Well Name	Well Number	US Well Number	Lease Number	Case Number	Operator
JRU APACHE	113H	3001555783	NMNM89051	NMNM89051	XTO PERMIAN
JRU APACHE	803H	3001555766	NMNM89051	NMNM89051	XTO PERMIAN
JRU APACHE	902H	3001555854	NMNM89051	NMNM89051	XTO PERMIAN
JRU APACHE	903H	3001555855	NMNM89051	NMNM89051	XTO PERMIAN

Notice of Intent

Type of Action: APD Change

Procedure Description: XTO respectfully requests approval to make the below listed changes to the approved APDs. 1. Casing design to be changed from the “4-String Design – Engineered Weak Point” (FIGURE F) to the “4-String Design – Open 1st INT x 2nd INT Annulus” (FIGURE D). An open annulus will be utilized and monitored during completions operations. Post completion, bradenhead squeeze will be performed to tie back the 1st intermediate x 2nd intermediate annulus. TOC will be placed into the 1st intermediate shoe but still below the base of Potash interval. 2. No changes to the cementing, casing or mud circulating system designs will be required for the requested change. 3. There is no new surface disturbance. Please refer to the R-111-Q well bore diagrams in the attachment reflecting the changes requested. WELL NAME API Number JRU Ap

Previous Design: 4-String Design – Engineered Weak Point**[Figure F] 4 String – 2nd Intermediate casing engineered weak point**

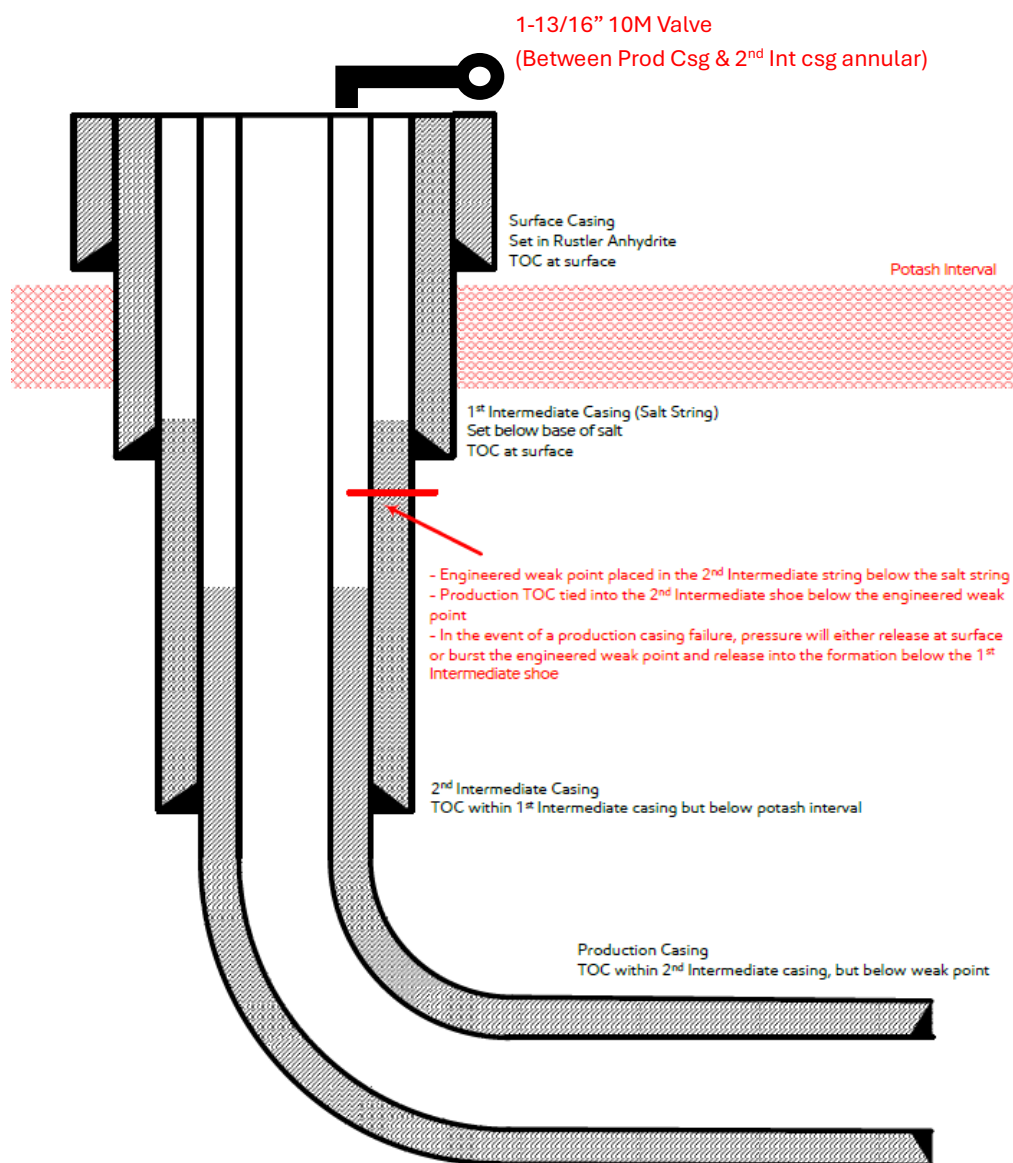
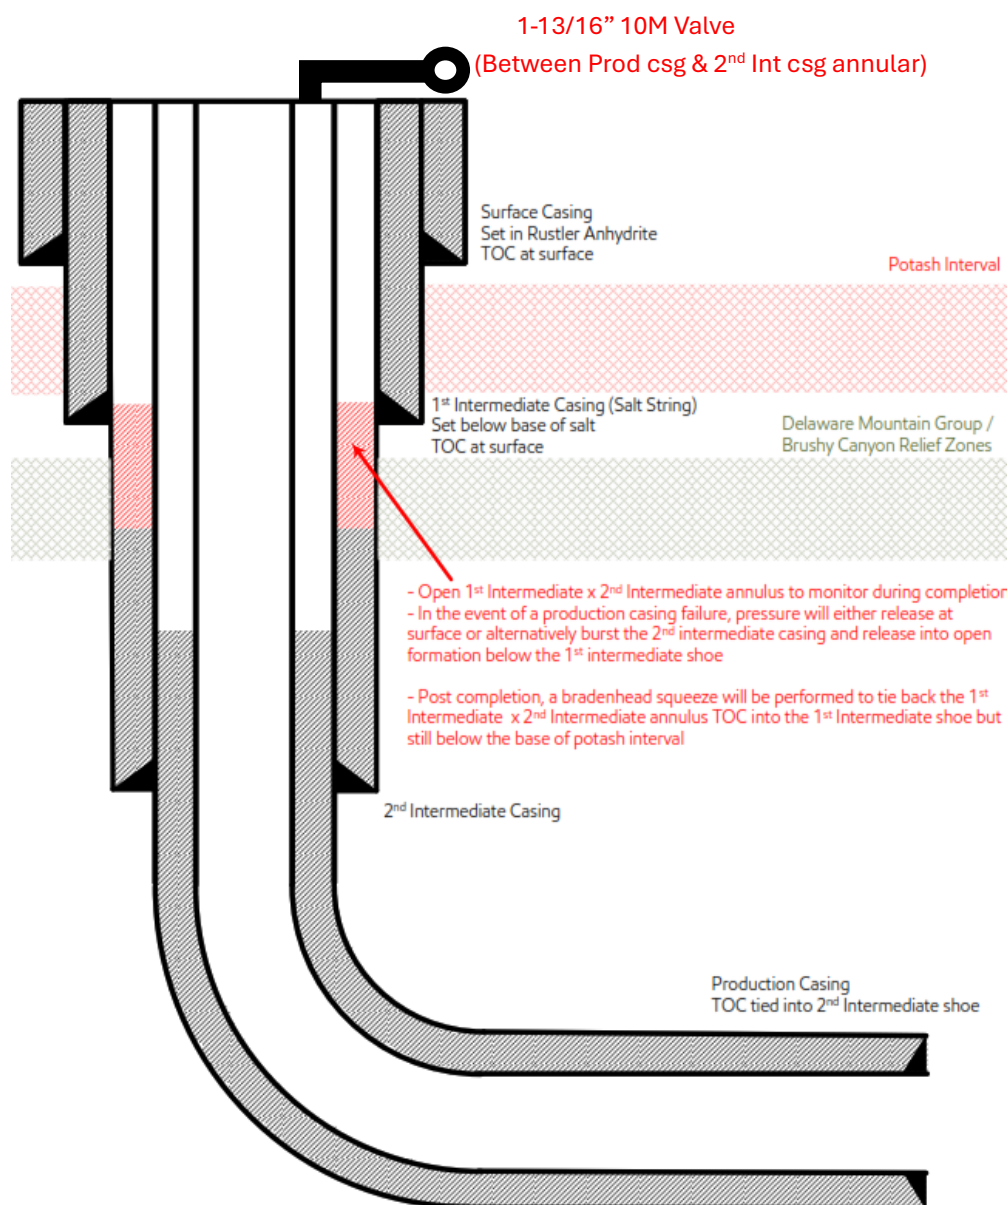
XTO respectfully requests approval to make the below listed changes to the approved APDs.

1. Casing design to be changed from the "4-String Design – Engineered Weak Point" (FIGURE F) to the "4-String Design – Open 1st INT x 2nd INT Annulus" (FIGURE D). An open annulus will be utilized and monitored during completions operations.

Post completion, bradenhead squeeze will be performed to tie back the 1st intermediate x 2nd intermediate annulus. TOC will be placed into the 1st intermediate shoe but still below the base of Potash interval.

2. No changes to the cementing, casing or mud circulating system designs will be required for the requested change.

New Proposed Design: 4 – String Design – Open 1st Int X 2nd Int Annulus (ICP 2 below relief zone)**[Figure D] 4 String – Uncemented annulus between 1st and 2nd intermediate casing strings**

- 1) Alignment with KPLA requirements per schematic above, leaving open annulus open for pressure monitoring during frac and utilizing new casing that meets API standards.
- 2) Contingency plans in place to divert fluids away from salt interval in event of production casing failure.
- 3) Intermediate 2 bradenhead squeeze to be completed within 180 days to tieback TOC to salt string at least 500ft but with top below Marker Bed 126.
- 4) Production cement to be tied back no less than 500ft inside previous casing shoe.
